**KNOXVILLE/KNOX COUNTY METROPOLITAN PLANNING COMMISSION
USE ON REVIEW REPORT**

▶ **FILE #:** 3-F-08-UR

▶ **APPLICANT:** K L REAL ESTATE CORP.

REVISED DEVELOPMENT PLAN FOR BALL CAMP VILLAS

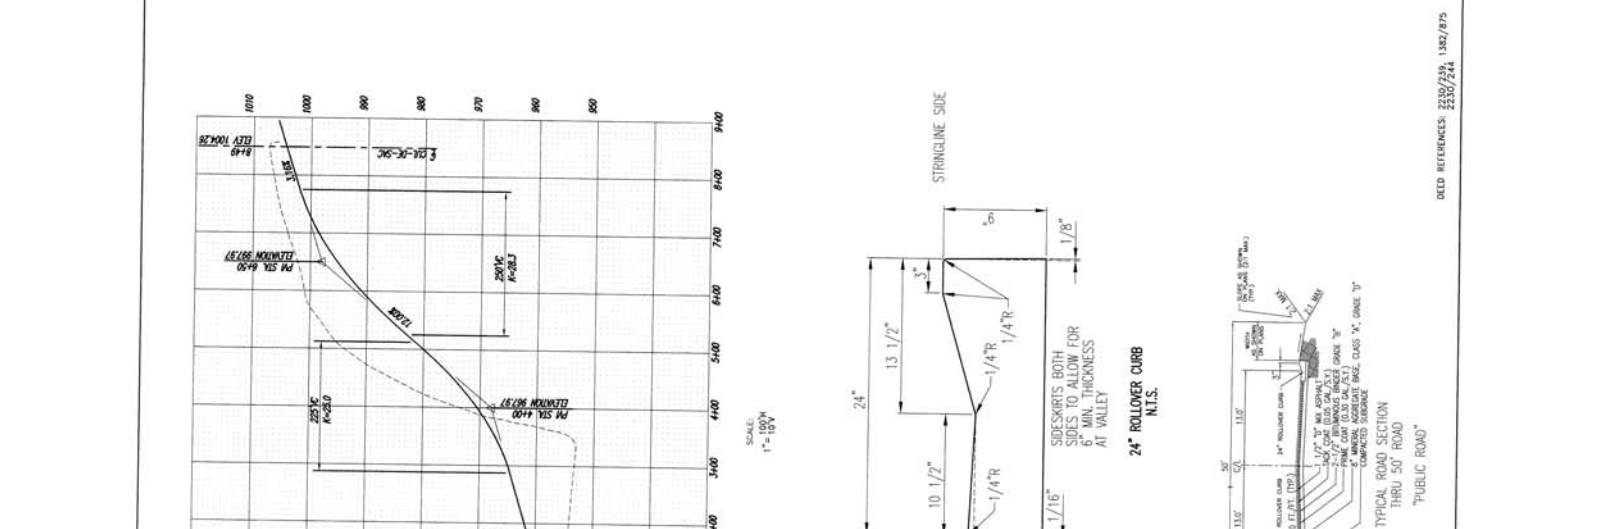
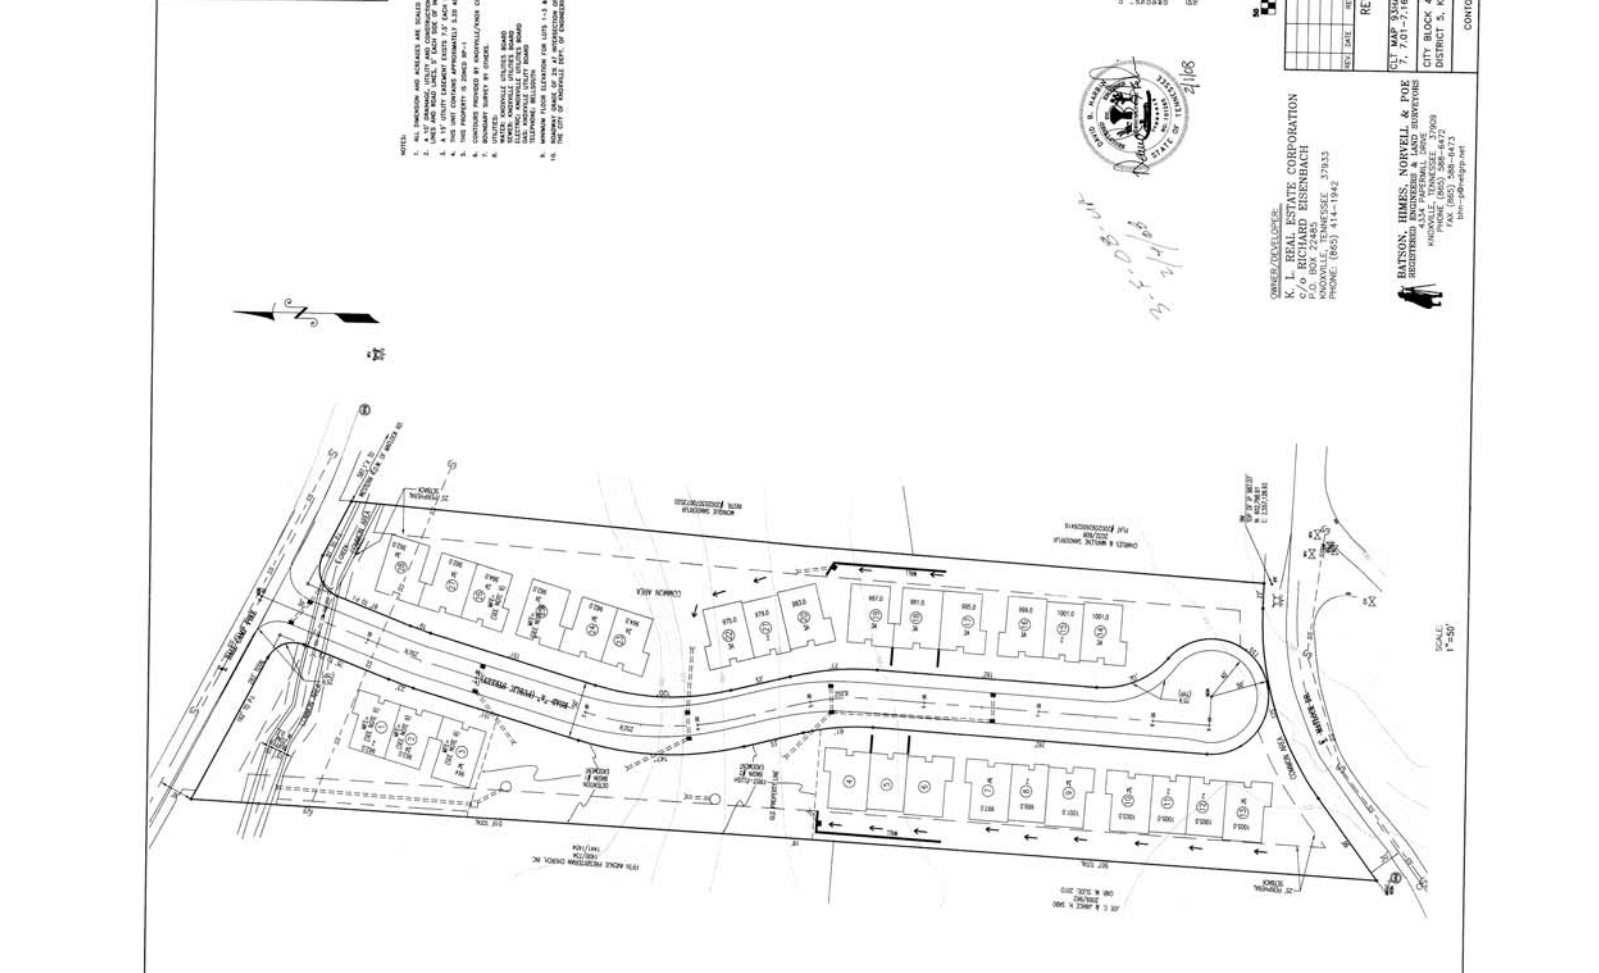
▶ **APPROVE the request for up to 28 attached dwellings as shown on the development plan subject to 11 conditions**

1. Connection to sanitary sewer and meeting any other relevant requirement of the Knox County Health Department.
2. Provision of a street name which is consistent with the Uniform Street Naming and Addressing System within Knoxville, Ord. O-280-90.
3. Meeting all applicable requirements and obtaining all required permits from the Tenn. Dept. of Environment and Conservation.
4. Meeting all applicable requirements of the Knoxville Department of Engineering
5. Reducing the grade at the intersection of Road A at Ball Camp Pk. To 1% unless otherwise permitted by the

Knoxville Dept. of Engineering

6. Approval of the proposed curb and gutter design by the Knoxville Engineering Dept.
7. Approval of a resubdivision of the property combining all existing parcels into one
8. Meeting all applicable requirements of the Tenn. Dept. of Environment and Conservation
9. Provision of a front minimum building setback of 20' from the property line for units with a one-car garage and a 15' setback for units with a two-car garage
10. Establishment of a homeowners association for the purpose of maintaining all commonly held assets including storm drainage facilities
11. A revised site plan reflecting the conditions of approval must be submitted to MPC staff for review and certification prior to the issuance of any additional grading or building permits

The applicant is proposing to develop this 5.20 acre tract into 28 attached residential condominiums at a density of 5.39 du/ac. This property was rezoned to RP-1 (Planned Residential) at a density of 1 - 5.9 du/ac by City Council on May 24, 2005. (4-N-05-RZ). Although the property has frontage on Matlock Rd., the applicant is proposing to access the development via Ball Camp Pk. A blue line stream crosses this site. Any proposed alterations to this stream will require the approval of the Tenn. Dept. of Environment and Conservation.
